SERVICE BULLETIN

Subject: Transmittal of Revision 1 to Service Bulletin V2500-ENG-79-0070.

OIL - PRESSURE OIL TUBES - ENGINE - INTRODUCTION OF REVISED OIL FEED SYSTEM
RESTRICTORS

V2500-ENG-79-0070

Scavenge tube assembly.
Figure 1

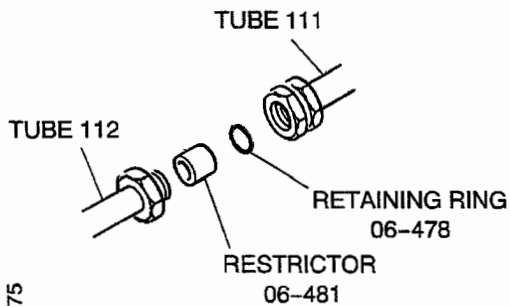
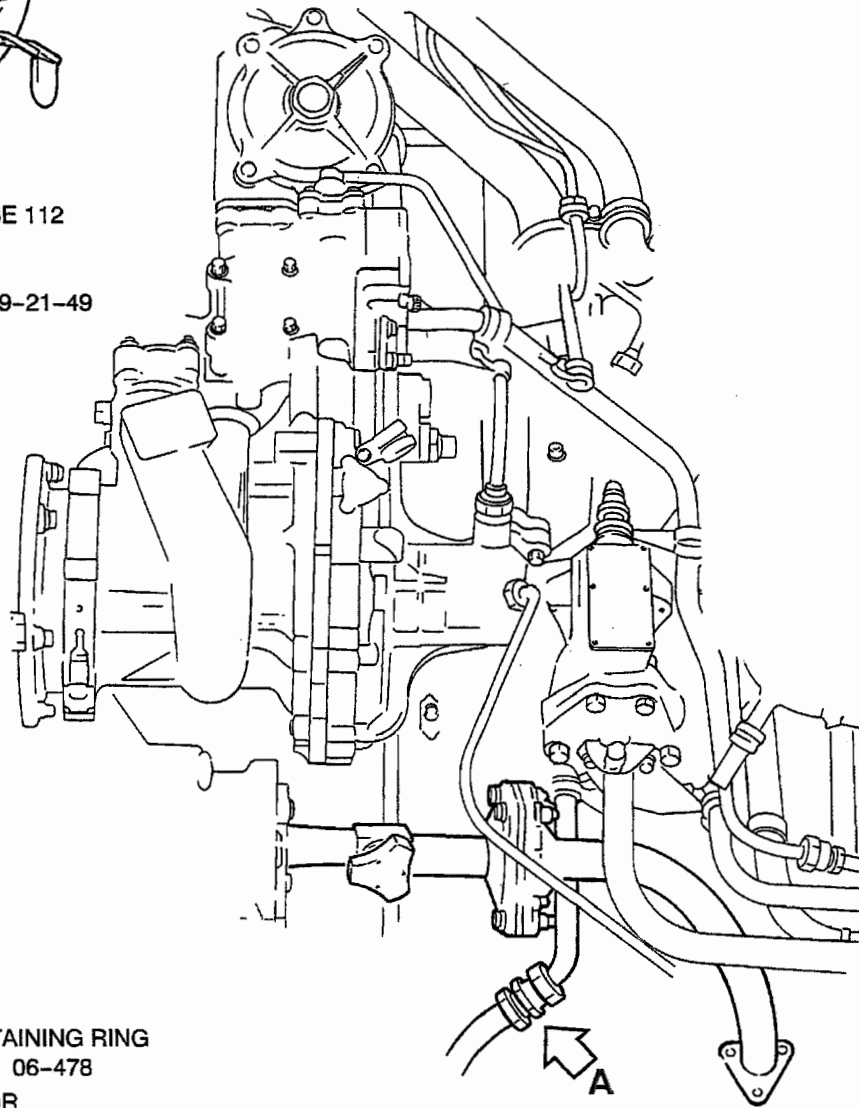
- (1) The filter assembly for the oil-feed tube assembly of the No.4 bearing has been revised, the orifice of the restrictor is reduced.
- (2) The restrictor between the oil-feed tube assembly of the No.5 bearing and the oil-feed tube assembly to the 4-Way connector has been revised, the orifice of the restrictor is reduced.
- (3) The restrictor between the disconnect to 5-Way oil tube assembly and the oil-feed to gearbox tube assembly has been revised, the orifice of the restrictor is reduced.

R (4) Disconnect the tube 112 from the tube 111 and remove the restrictor (Pre SB) and
R remove and discard the retaining ring Ref Figure 1.

R (1) Install the restrictor (Post SB) (06-481) and a new (06-478) retaining ring 1 off in the tube
R 112 Ref Figure 1.

R (2) Connect the tube 112 to the tube 111. Torque the tube connector to 283 to 310 lbf_{in}
R (32 to 35 Nm). Safety with CoMat 02-126 lockwire.

No.5 bearing oil feed assembly
Figure 2

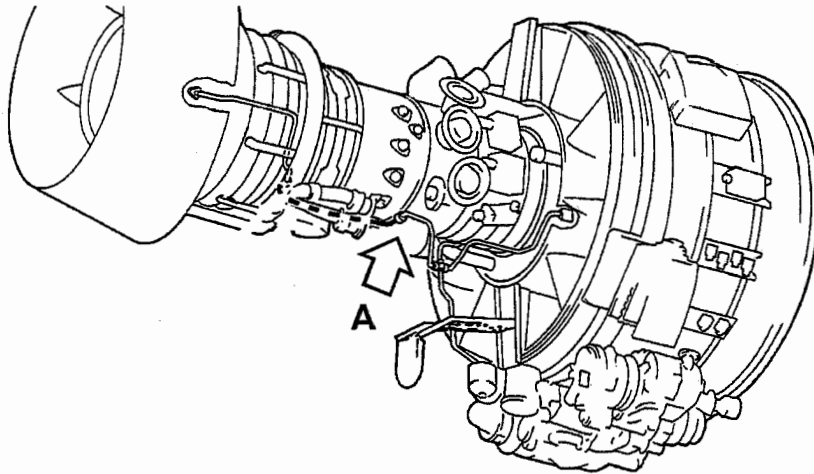
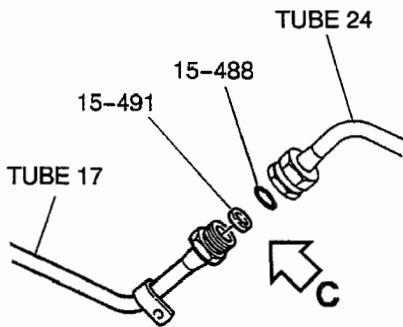
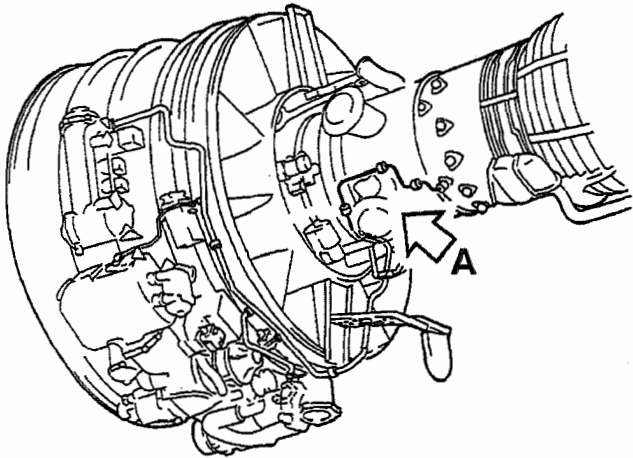
R (5) Disconnect the tube 17 from the tube 24 and remove the restrictor (Pre SB) and remove
R and discard the retaining ring Ref Figure 2

R (3) Install the restrictor (Post SB) (15-491) and a new (15-488) retaining ring 1 off in the tube
R 17 Ref Figure 2

R (4) Connect the tube 17 to the tube 24. Torque the tube connector to 283 to 310 lbf_{in}
R (32 to 35 Nm). Safety with CoMat 02-126 lockwire.

No.4 bearing oil feed tube assembly
Figure 3

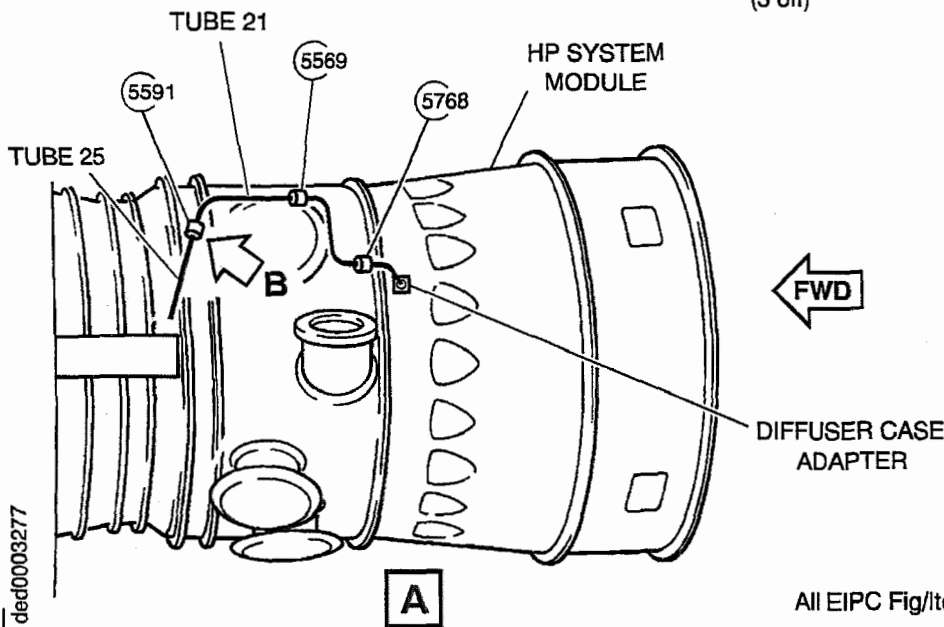
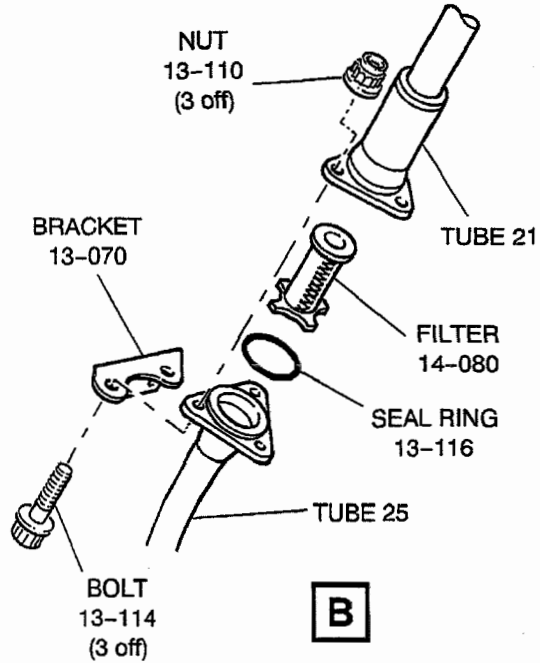
R (6) Remove the tube 21 Ref Figure 3

R (h) Remove the filter (Pre SB) from the tube 21.

R (5) Install the tube 21 Ref Figure 3

R (b) Install the (Post SB) filter into the tube 21

R (g) Attach the tube 25 to the tube 21 with the bracket, the three bolts and the three nuts.
R Torque the nuts to 85 to 105 lbf_{in} (10 to 12 Nm).
